**TO: PROSPECTIVE BIDDERS** **DECEMBER 10, 2021**

**RE: IFB-6711 – NEW CONSTRUCTION OF COMMUNITY SCHOOL 35**  
**ADDENDUM NO. 4 - CITY RESPONSE TO REQUESTS FOR INFORMATION AND CLARIFICATIONS**

**2 MECHANICAL ROOM PART PLAN**  
E300

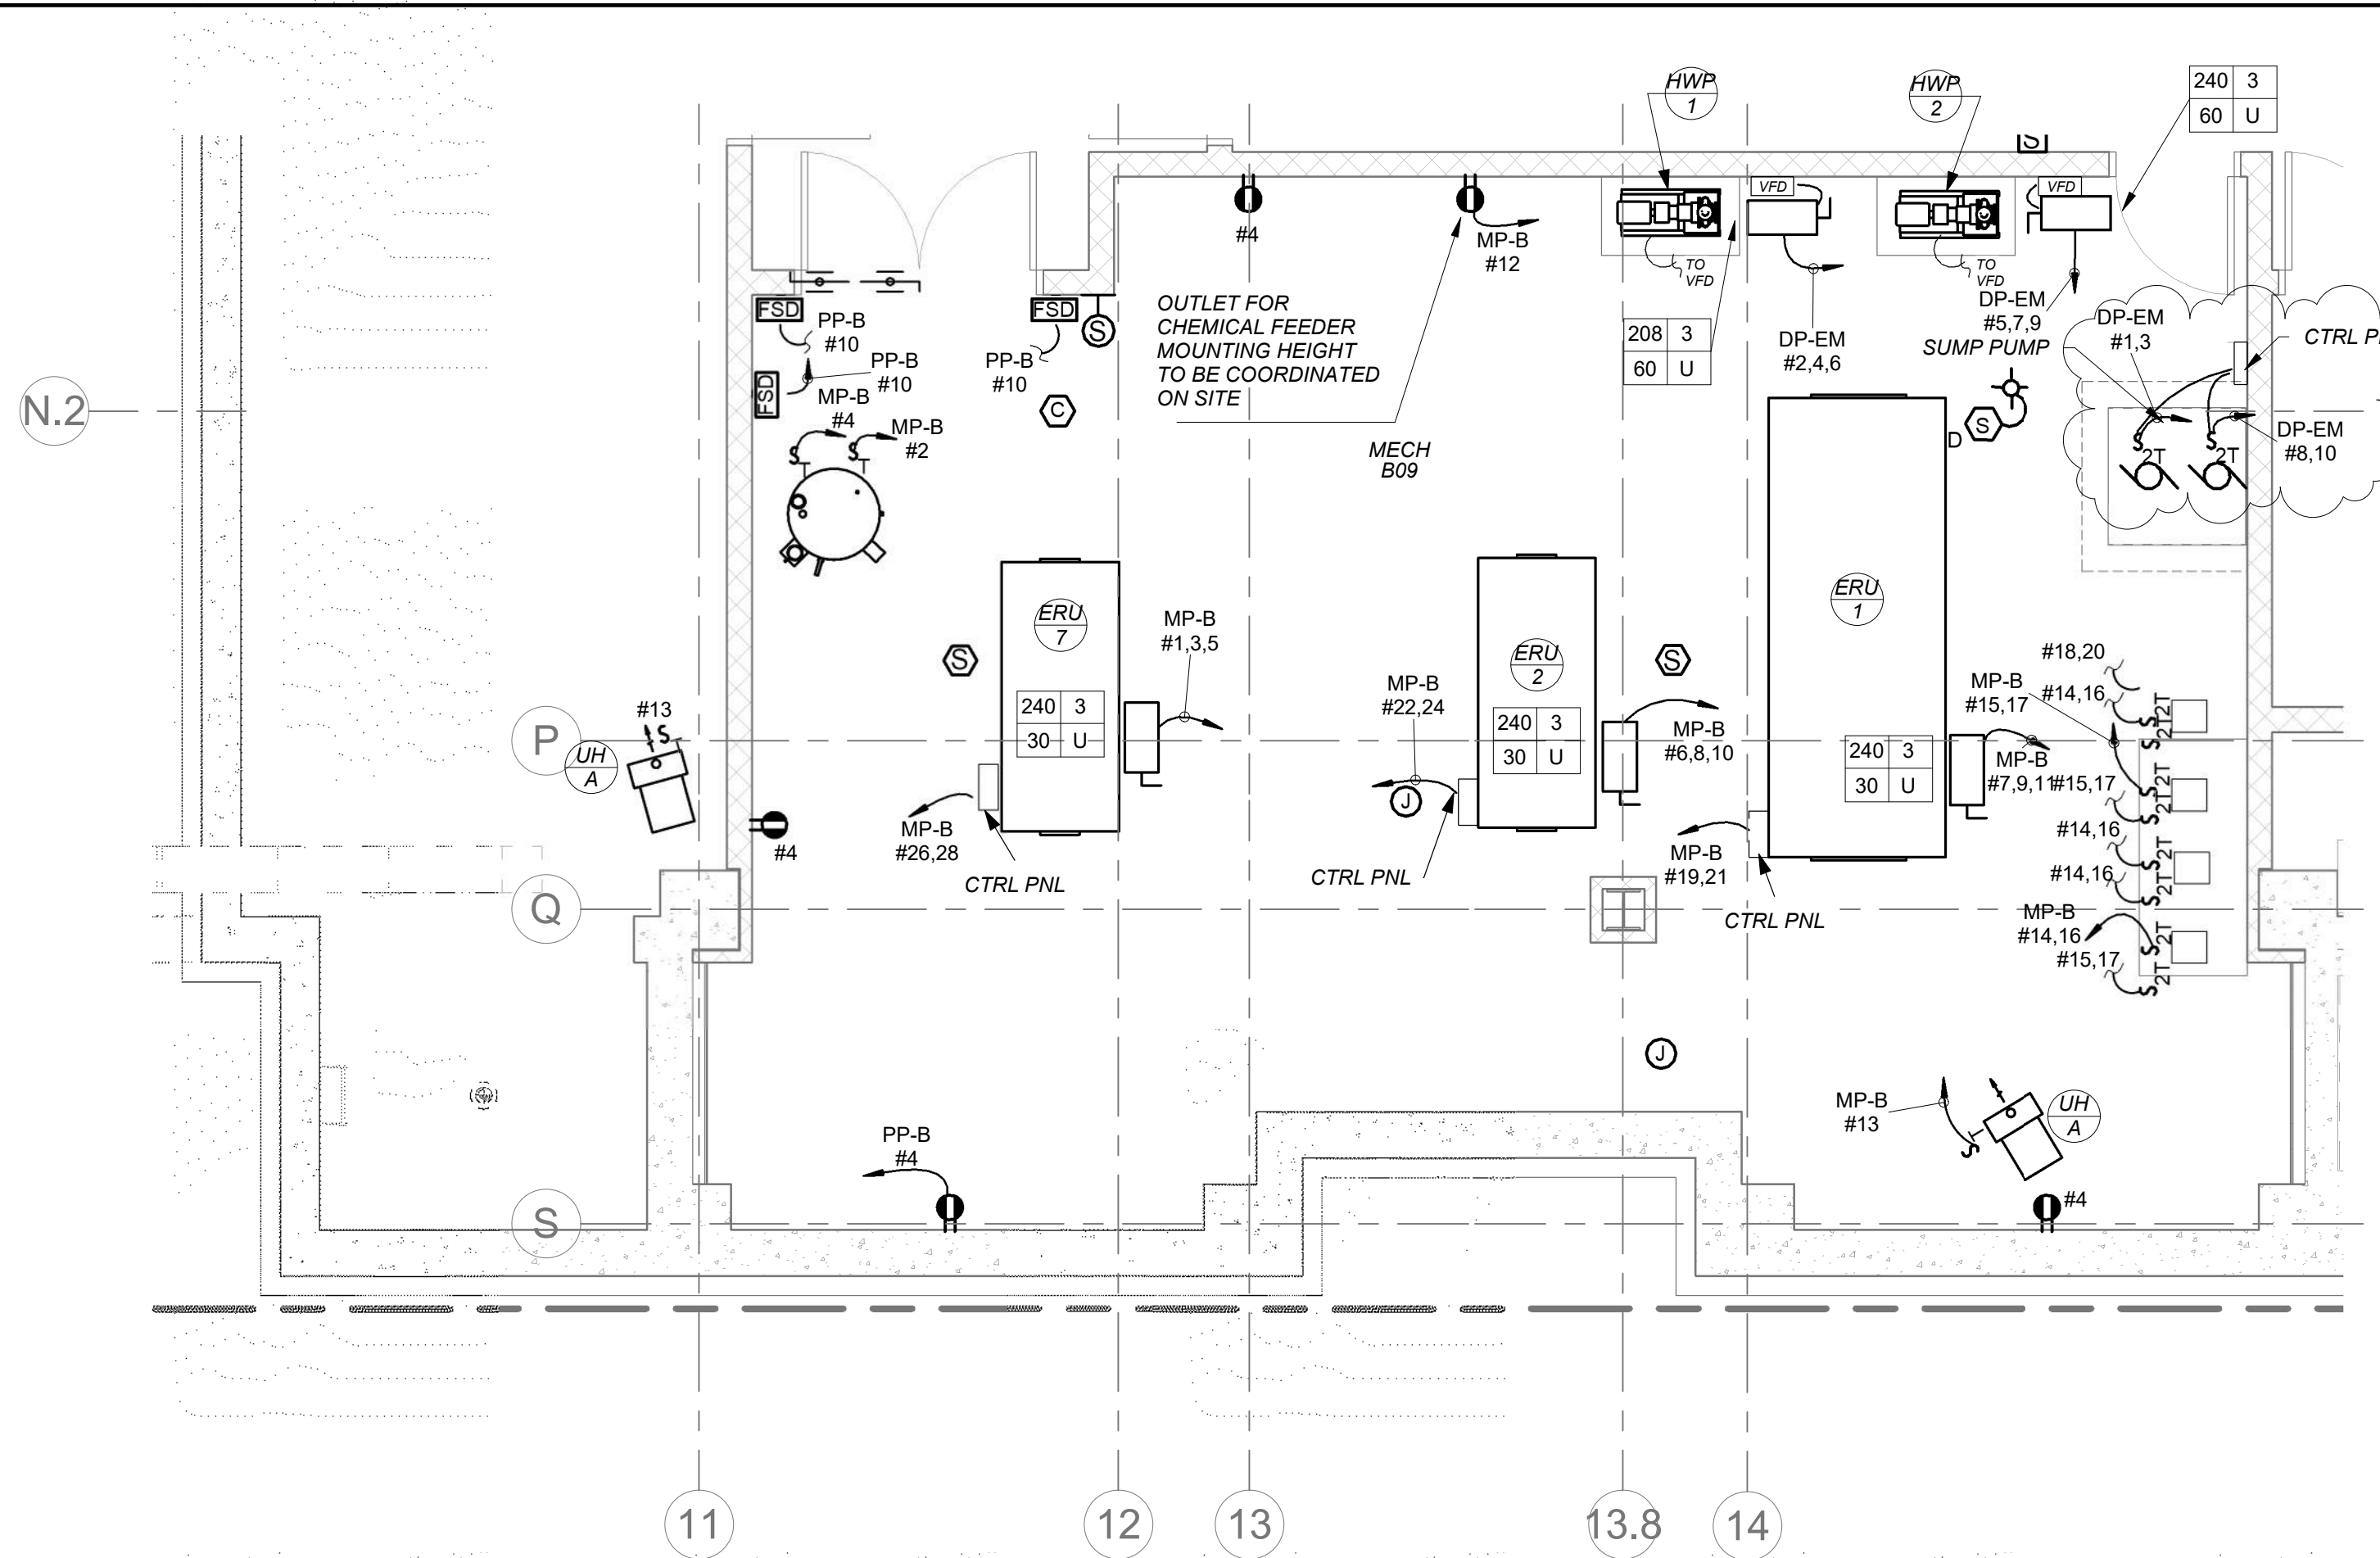
**18. DRAWING E300 – BASEMENT POWER AND FA PLAN**

1. Relocate water flow and tamper switch in Stair B SBB.
2. Jockey Pump circuit changed to panel board DP-EM. Provide 20amp-3P CB with 3#12+1#12 -3/4”C.
3. Sump Pump Control panel location shown the drawing.

**1st FLOOR POWER AND FA PLAN**

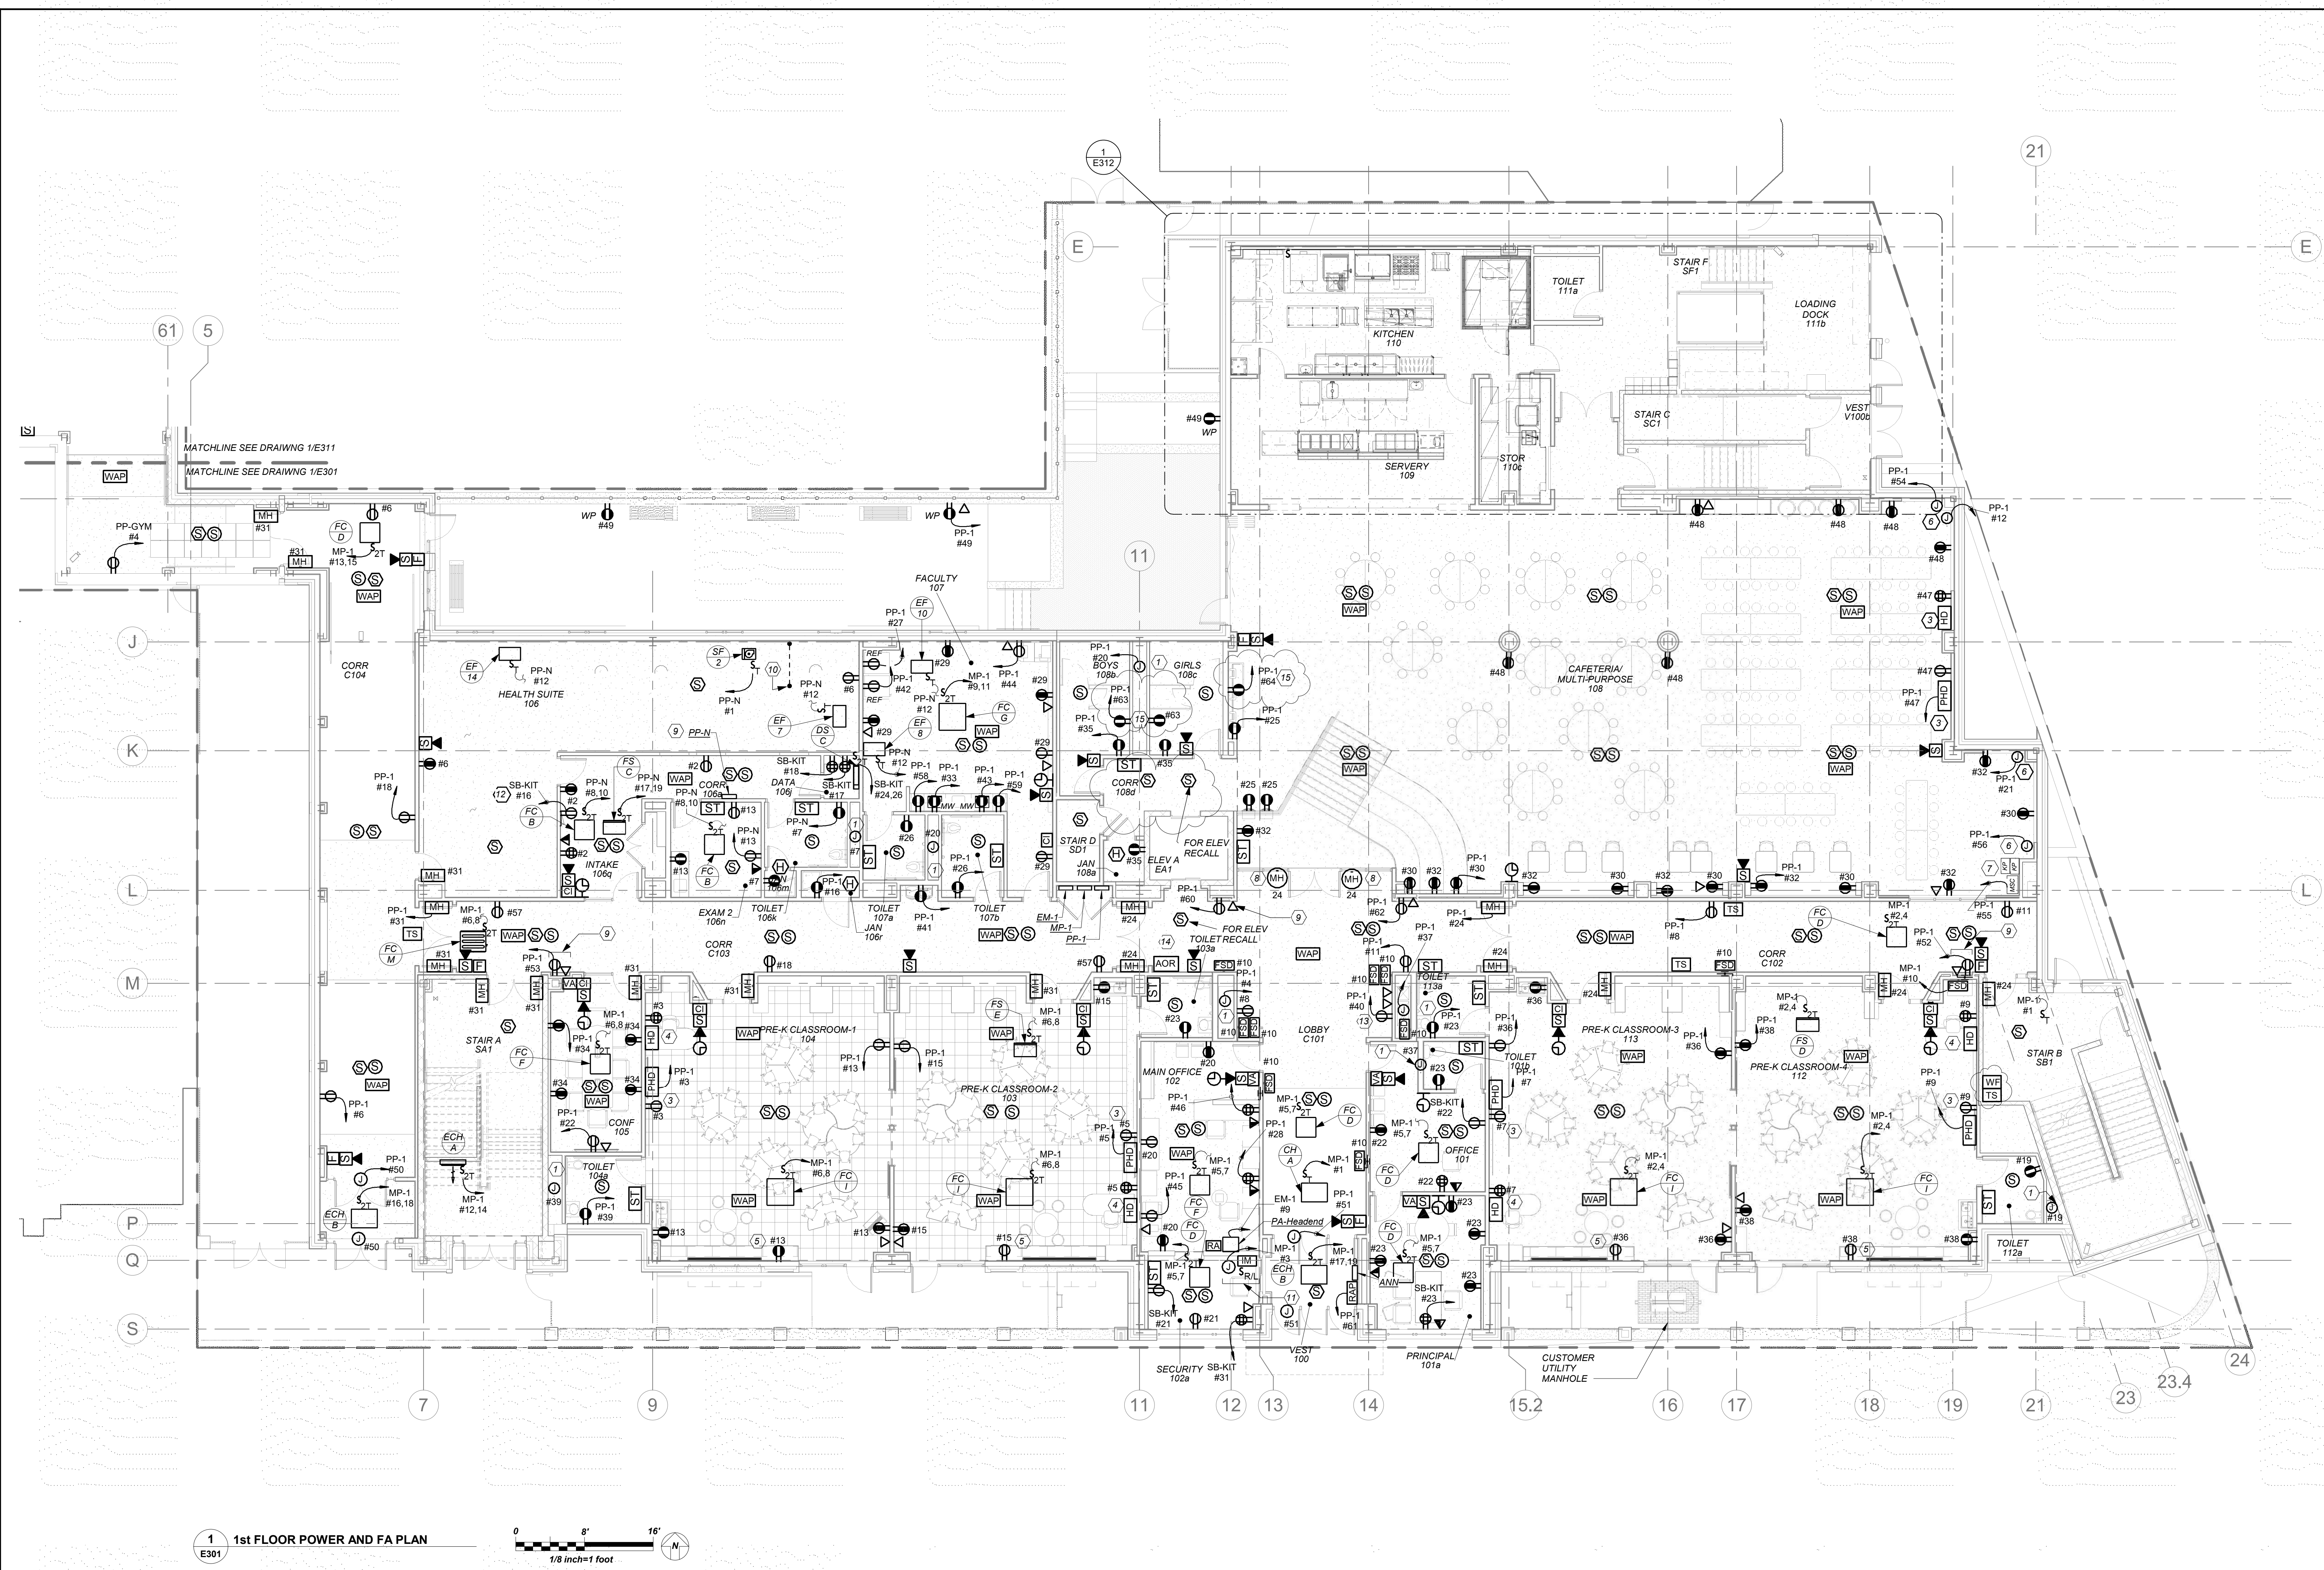
**19. DRAWING E301 – FIRST FLOOR POWER AND FA PLAN**

1. Add GFI outlet with new branch circuit, PP-1#63 with 2#12+1#12G-3/4”C under sink enclosure in Boys Bathroom 108b and Girls Bathroom 108c to serve the power supply for Auto faucet. Exact mounting location shall be coordinated with plumbing contractor.
2. Add GFI outlet with new branch circuit, PP-1#64 with 2#12+1#12G-3/4”C under sink enclosure in cafeteria 108 to serve the power supply for Auto faucet. Exact mounting location shall be coordinated with plumbing contractor.
3. Delete Heat detector in Corridor 108d and replace with smoke detector. Add strobe only device mounted on the outside bathroom wall.
4. Relocate water flow and tamper switch in Stair B SB1 as shown on the drawings.
